# Technical Service Bulletin

MODEL(S)  
AFFECTED: **Tennant 5700XP (serial numbers 0022000-0025130)**

SUBJECT: Machines may move while charging if the operator forgets to turn off the key switch before charging the batteries.

**New Interlock kit installed**

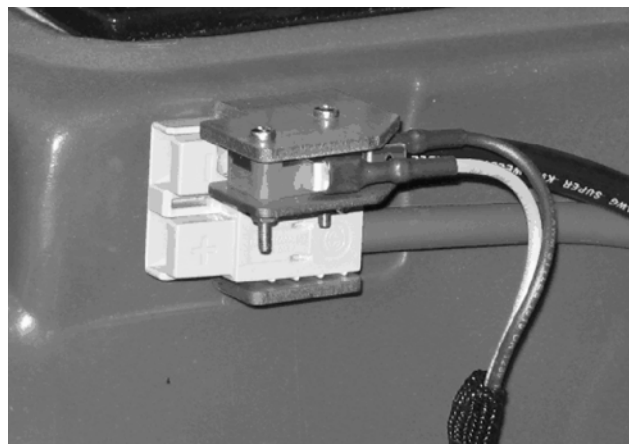
NOTES: Operator must **turn off the machine before charging** (as stated in the Operator manual) before charging the batteries.  
Interlock kit contains parts that prevent the machine from moving if the key switch is left on while the batteries are charging.  
Order Interlock kit 9002011. The IB for this kit is 340805.  
Questions, contact the Tennant Customer Service Department at (800) 553-8033.

PURPOSE: Prevent machine from moving while the batteries are charging.
